SERVICE ACTION: F800 Engine Cover Screw Torque - Bulletin 11 001 07 (022)

**Subject:** Checking security of threaded fasteners, engine-block covers

**Models:** F 800 S / ST (K71)

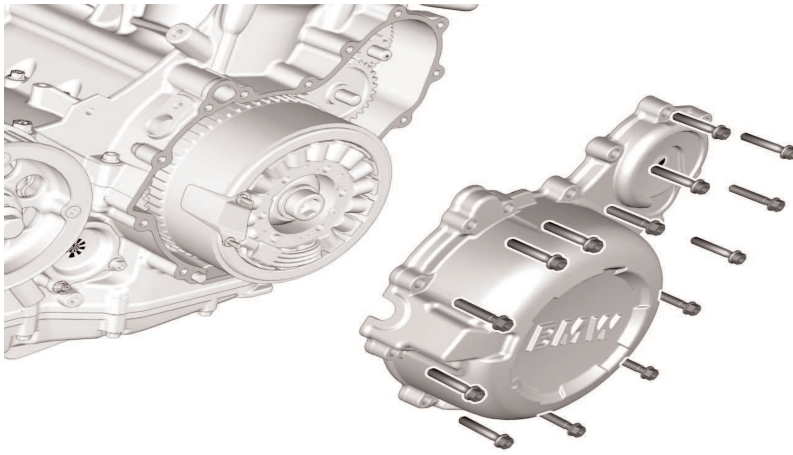
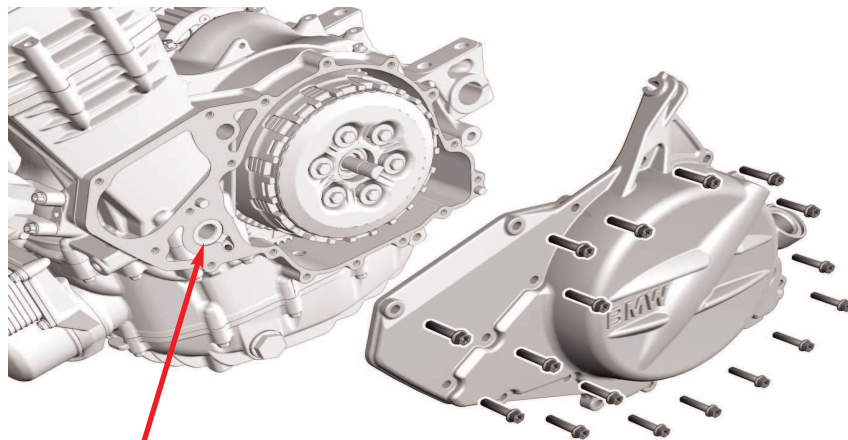
**Details:** During the first hours of engine operation, the pretension of the threaded fasteners securing the engine-block covers diminishes because the coating on the covers is expelled from the areas underneath the heads of the screws. This can result in two kinds of leaks:

1. Oil weeping at the sealing face between cover and engine block; clearly visible, but generally not critical in terms of engine operation.
2. An "internal" leak at the clutch side cover gives rise to the risk of damage to the engine: the pressurised oil that lubricates the conrod bearings flows through the left engine block cover. A leak from the pressurised oil duct to the sump (see bottom photo, arrow) where the oil is not under pressure, is not visible from the outside, but it causes a drop in oil pressure.

When the engine of an F800 affected by this problem is warm and idling, the oil pressure telltale light might show intermittently.

**Production Solution:** Currently produced motorcycles will have the coating from the areas of the engine-block cover that will be contacted by the heads of the securing screws removed at assembly. Specifically, from engine number 08087308 onward, the areas of the covers underneath the screw heads have been factory prepped.

**After-sales Solution:** In a once-only check, the next time a motorcycle in the range affected is brought into the workshop, check the security of all engine-block cover screws (see photos) by application of a tightening torque of 12 Nm.  
If the oil pressure telltale light shows when the engine is running, always check first to ascertain whether the left engine-block cover gasket is cracked, and replace if necessary.
